BUILDING B FIRST FLOOR PLAN

DEVELOPMENT HUMPHREYS DRIVE

SHEET A5

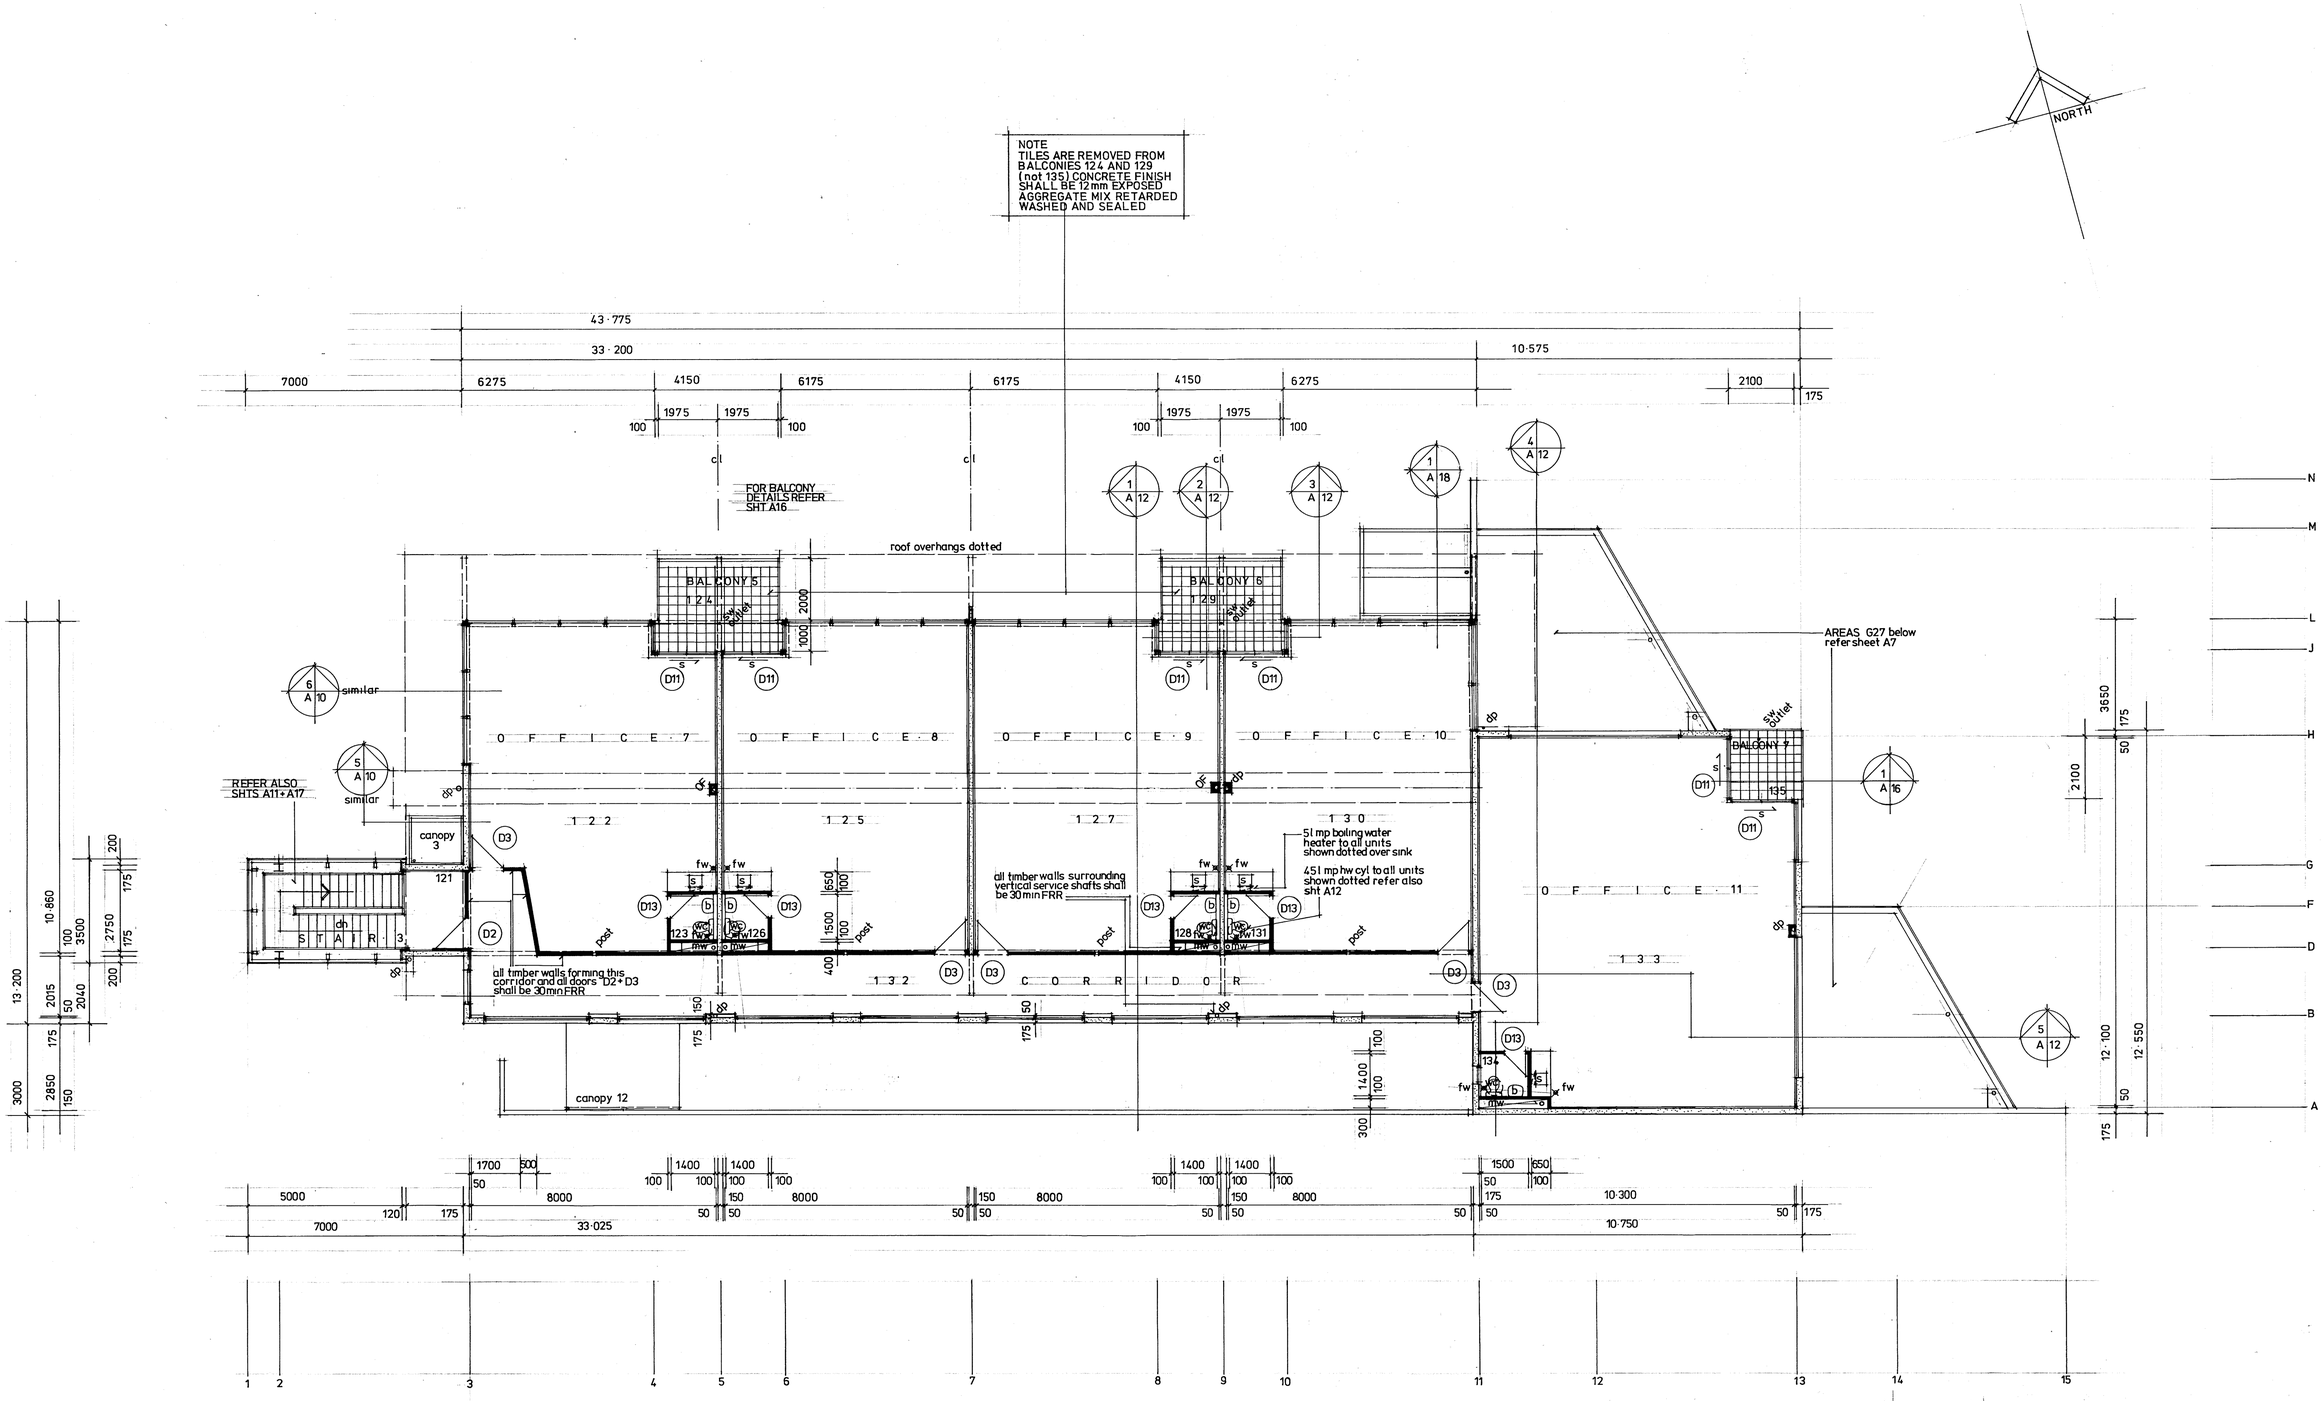
AMENDMENTS	
10 · 8 · 05	canopies 13 · 14 · 15 · 16 removed roof areas above G27 extended
20 · 11 · 05	tiles removed from balconies 5 and 6 / downpipe on grid line 11 area 130 moved to grid line 9 / canopy 4 removed - new lobby G30 roof added / main waste stack in duct area 134 re-positioned
